City of Detroit
Inter-Departmental Communication

RE: Petition No. 1282
Requested Encroachment at 20603 Berg Road (With A Monitoring Well)

PROVISIONS FOR ENCROACHMENT For Petition 1282

REQUEST ENCROACHMENT
 INTO BERG
 AT 20603 BERG
 (With Monitoring Well)

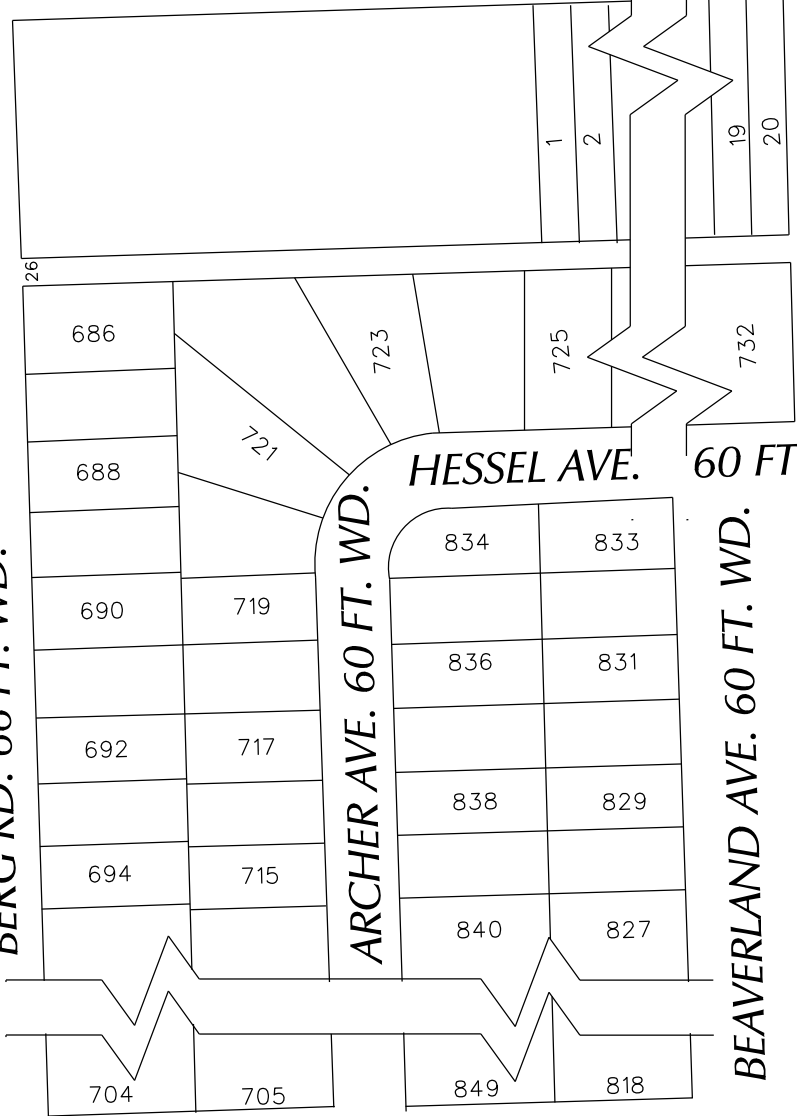
- DWSD has no objection to the requested encroachment provided that the attached Provisions for Encroachment are strictly followed.

- Our records indicate that there are water mains and sewers which are located in the vicinity of the proposed project limits.
- It is DWSD's requirement that any proposed utility crossing DWSD water mains or sewers perpendicularly must maintain a minimum of 18 inches vertical clearance. Also any proposed utility running adjacent to DWSD water mains and sewers must maintain a minimum of 5 feet lateral clearance including any conduit and/or manholes walls. No utility is allowed to run along the top of the water main or sewer.

- There are possibilities of several water and sewer service lines crossing in the vicinity of proposed work, field verify their location and depth to maintain our required clearance.
